SUNDRY NOTICES AND REPORTS ON WELLS
Do not use this form for proposals to drill or to re-enter an abandoned well. Use Form 3160-3 (APD) for such proposals.

North Alamito Unit 235H (FKA Lybrook G30-2307 02H)

The proposed Lybrook G30-2307 02H well, which was approved by the OCD on June 26, 2014, will now be a part of the North Alamito Unit. Encana is submitting this sundry to change the well name from the Lybrook G30-2307 02H to the North Alamito Unit 235H.

In addition to the name change, the BHL was modified to change the wellbore's orientation from oblique to transverse. Please note, the SHL footages changed slightly due to using a different surveyor to re-survey the location - the footprint of the pad is not affected.

WELL LOCATION AND ACREAGE DEDICATION PLAT

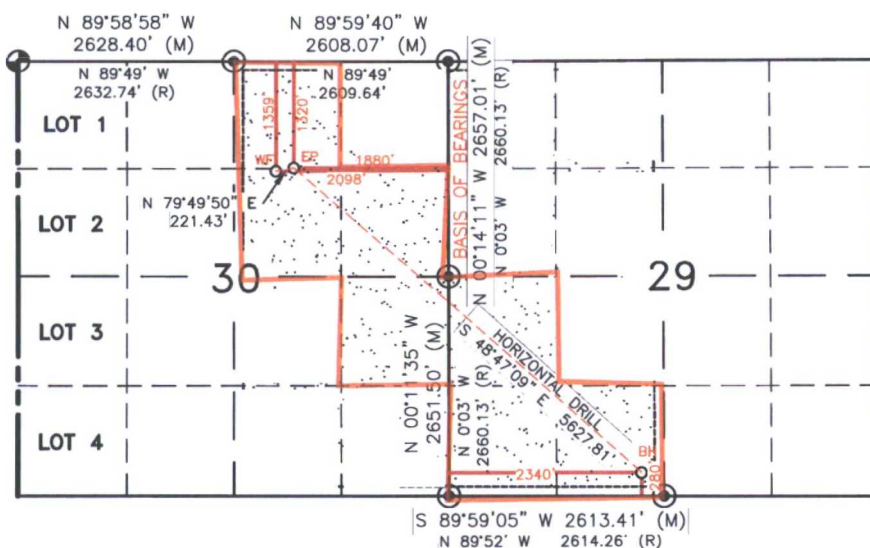
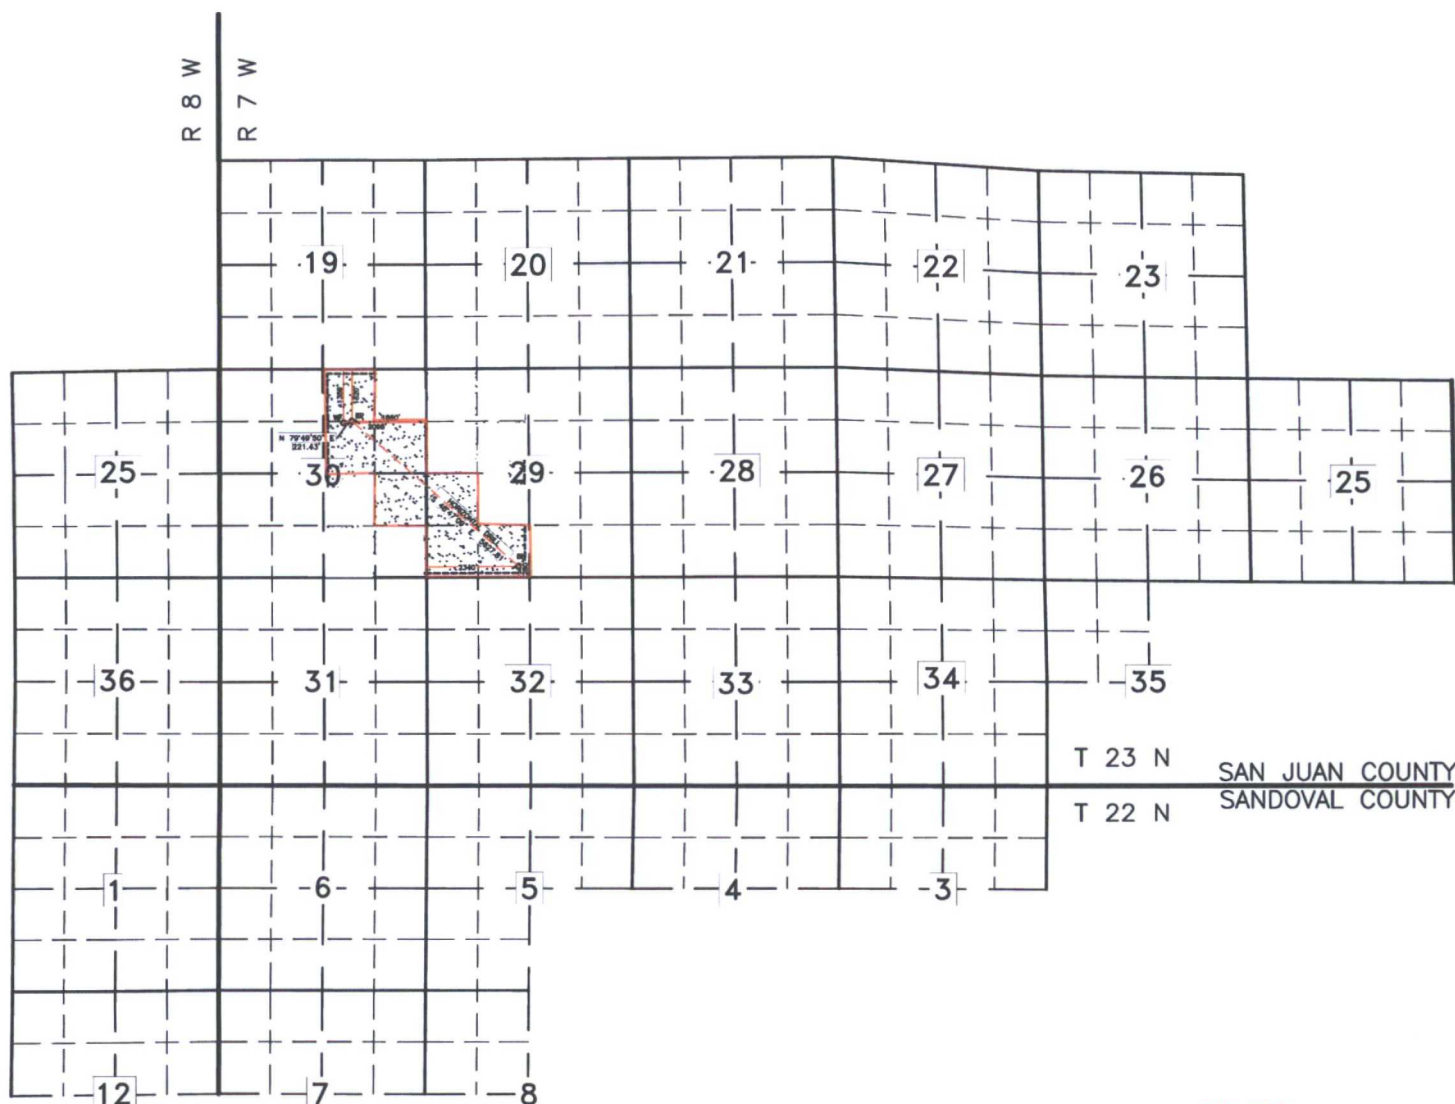
Please find attached an updated C-102, directional drilling plan, 10-Point drilling plan, and wellbore diagram that reflect these changes. Note, the drilling plans were also updated to remove the conductor.
